STAFF REPORT

SUBJECT:	PRS 21-0359 RV/S	PLANNING AREA:	Riverview
REQUEST:	Minor Modification to a Planned Development	SECTOR	South
APPLICANT:	Sentosa Riverview Owner LLC		
Existing Zoning : PD 18-1049		Comp Plan Category: RES-12

Figure 2 –PD Plan

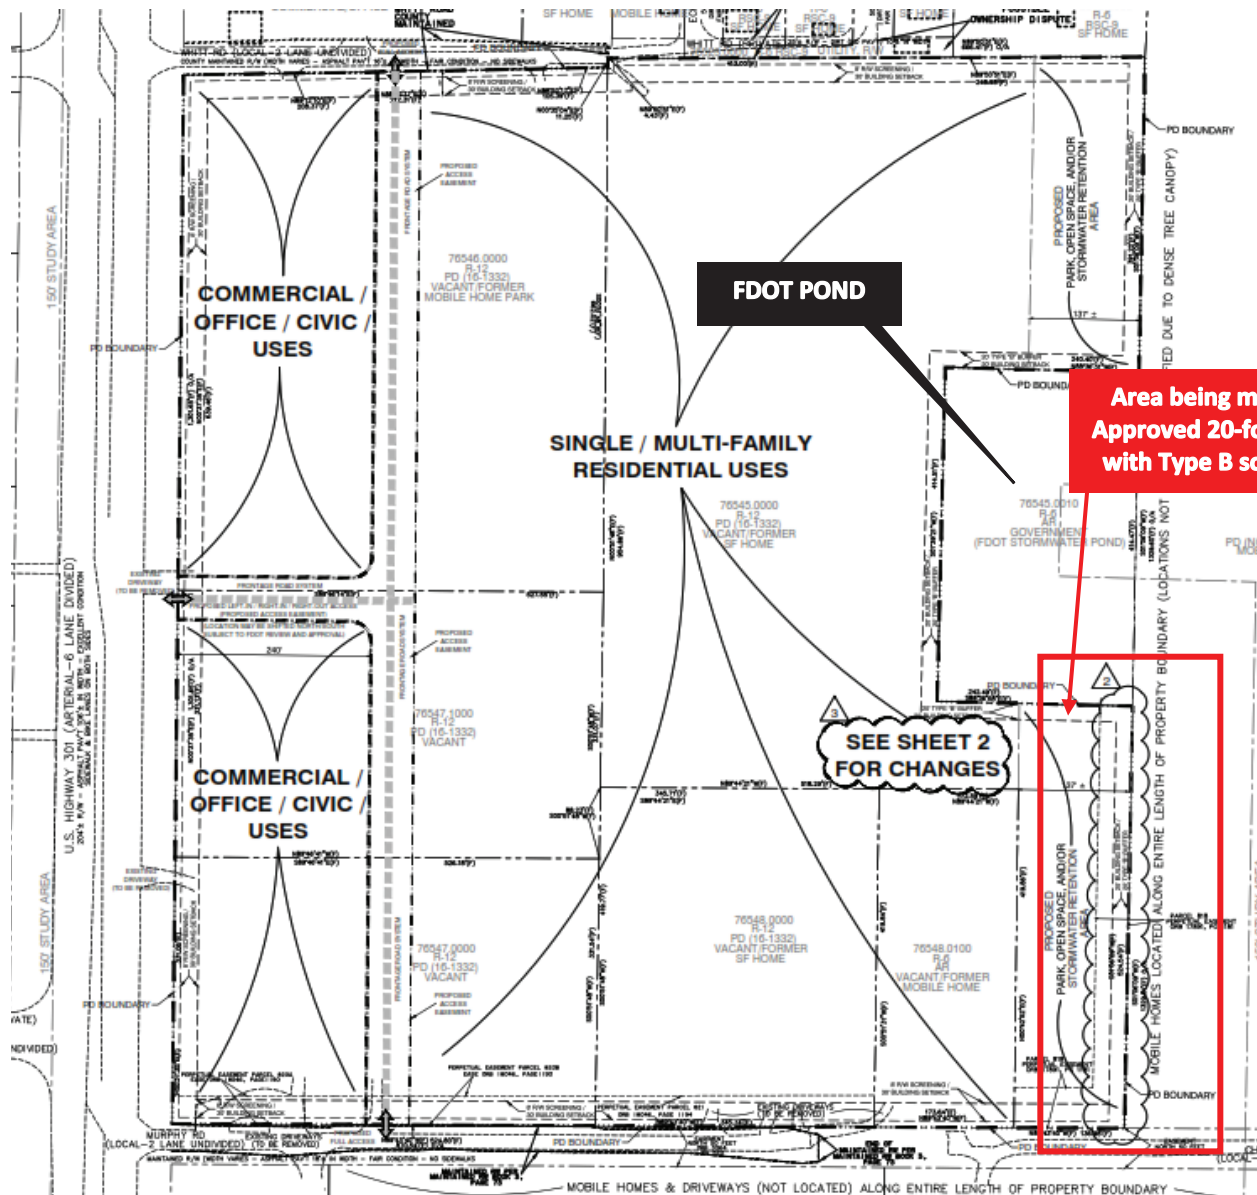
The PD today allows a mix of uses for residential, civic, office and commercial development. The general site plan for the PD depicts areas for development for the different uses. The approved uses include:

Figure 3 – Sheet 2 of 2 PD Plan – Proposed Plantings and Location

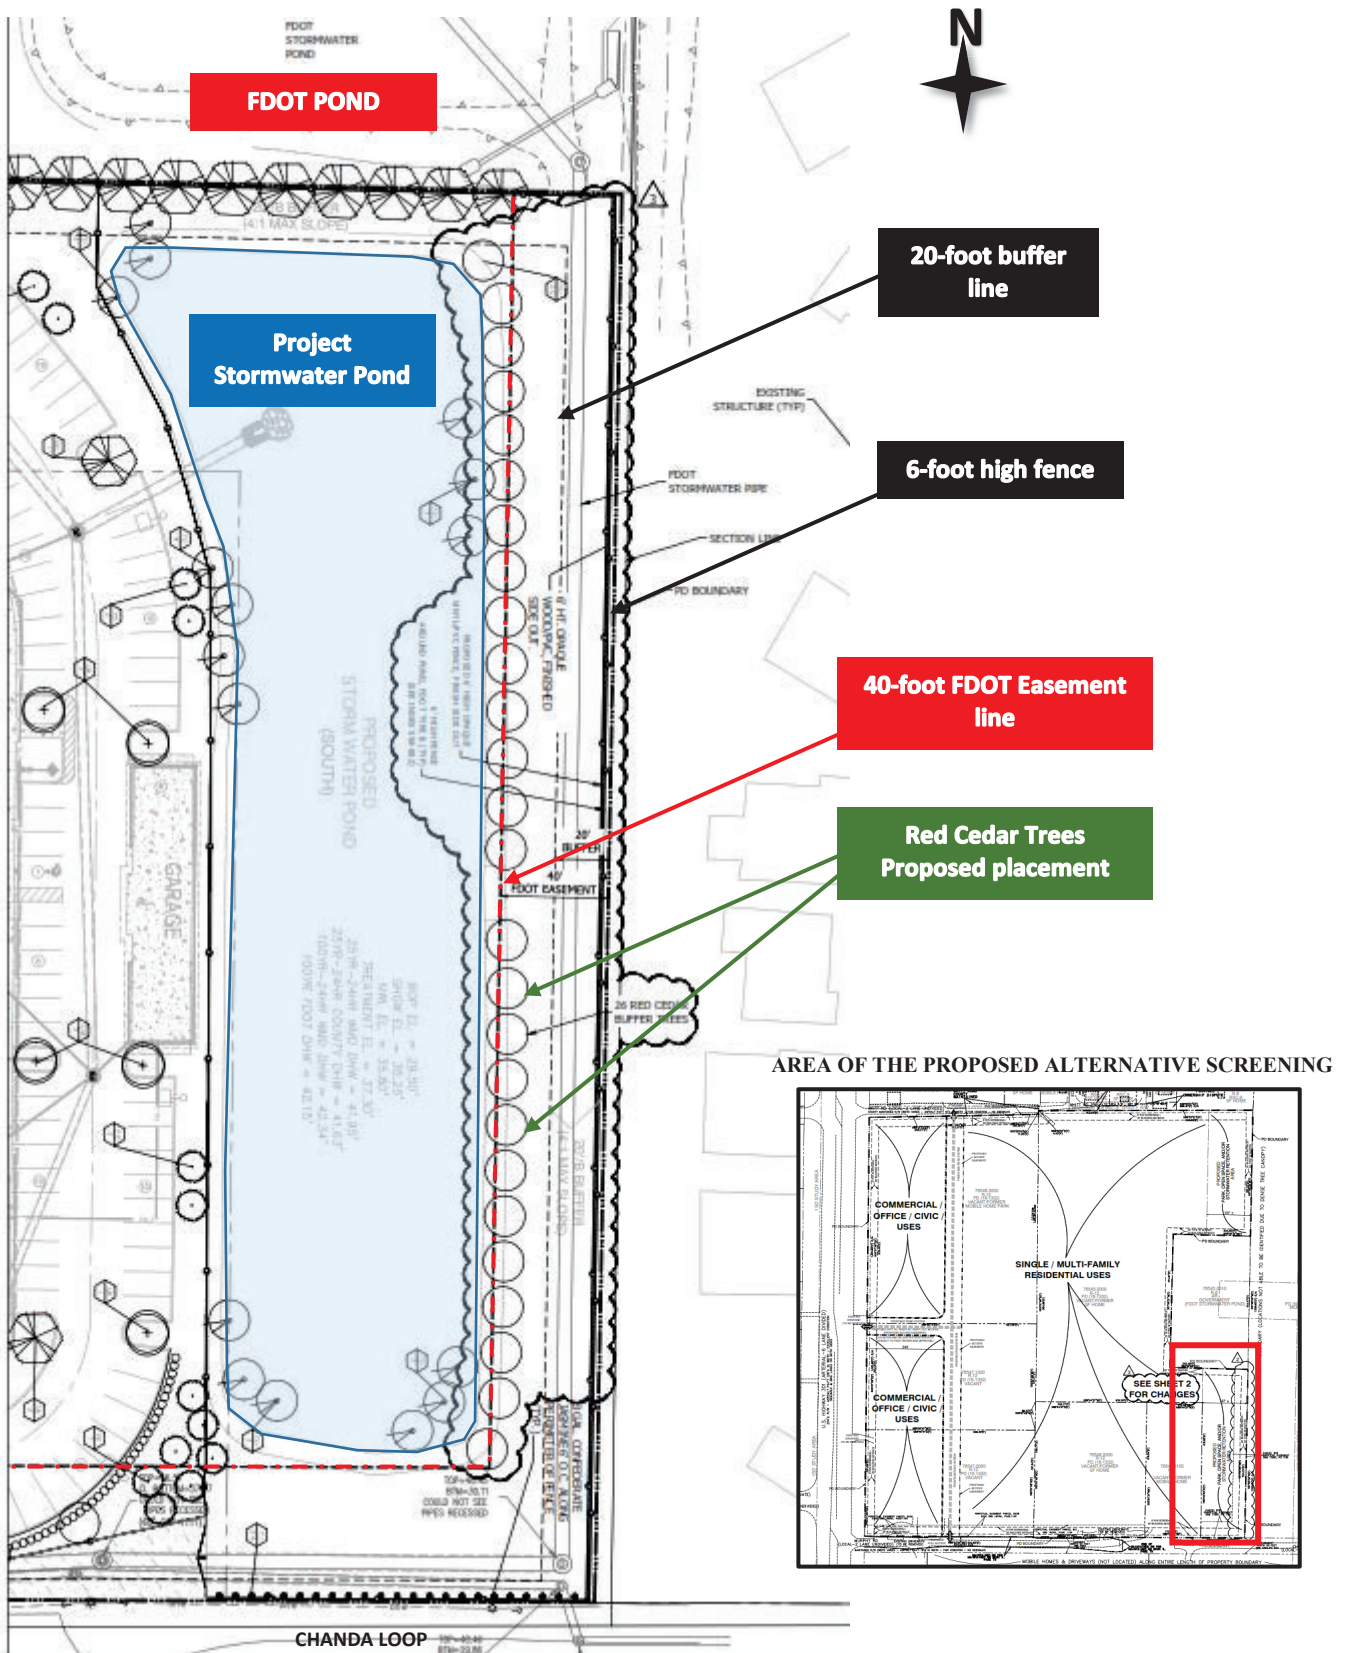
Due to an FDOT drainage and access easement located on the SE portion of the PD, the applicant proposes an alternative landscape screening and placement where plantings, subject to the Type B screening standards, are required. The applicant proposes to plant 26 Red Cedar trees instead of the previously proposed oaks approximately 36 feet from the PD line. A solid, 6-foot high PVC fence is being provided,

An FDOT pond is currently located adjacent to the east of the PD. Per the project narrative, based on FDOT feedback, a drainage pipe and ingress/egress (maintenance access road) to the pond is in place on the southern section of the east boundary line of the site. The access road runs along 524.54' of the south side of the east boundary line, extending from Chanda Loop north to the FDOT Pond. Due to the existence of this drainage and access easement (40 feet wide), the required trees, per the 20' Type B screening (a row of evergreen shade trees which are not less than ten feet high at the time of planting, a minimum of two-inch caliper, and are spaced not more than 20 feet apart, planted within ten feet of the property line), need to be relocated so that they do not interfere with the easement, therefore, placing them outside the required 20-foot buffer area. The applicant proposes placement of the red cedar trees (a plant species that meets the requirement of the Type B screening) on the west side of the easement, 36 feet from the PD line (Figure 3).

The applicant provided a PD variation request from LDC 6.06.00, Landscaping, Irrigation and Buffering Requirements for the alternative screening as stated in the previous section of this report. The applicant states that the location of the perimeter buffer and trees are within the FDOT maintenance easement that provides ingress and egress to their stormwater pond. Additionally, a stormwater pipe runs under the same easement. Providing the buffer plantings in the traditional area of the buffer would prevent the use of the ingress/egress access for FDOT maintenance and potentially jeopardize the stormwater pipe due the future root intrusion. The existence of the easement prevents the required plantings within 10 feet of the parcel line in the required 20-foot buffer area per the LDC Section 6.06.06.C.4.b.

Natural Resources staff reviewed the request and does not object. The proposed relocation and change of species of the required Type B buffer trees as shown on the plans, provides a tree species with a less invasive root system than the originally proposed live oaks. The proposed red cedar trees should have minimal conflict with the existing underground stormwater pipe located in the drainage easement. The relocation of the trees places them outside of the Code required location parameters but they are still located between the apartment buildings and the property to the east with the less intense zoning.

1. The proposed relocation and change of species of the required Type B buffer trees as shown on the plans submitted on March 8, 2021, provides a tree species with a less invasive root system than the originally proposed live oaks. The proposed red cedar trees should have minimal conflict with the existing underground stormwater pipe located in the drainage easement. The relocation of the trees places them outside of the Code required location parameters but they are still located between the apartment buildings and the property to the east with the less intense zoning.

- 4.2 The planting types and buffer area along the southeast portion of the PD, south of the FDOT pond, shall be as indicated in Sheet 2 of 2 of the General Site Plan. The trees required for screening shall be permitted to be placed within 50 feet of the southeastern property line.
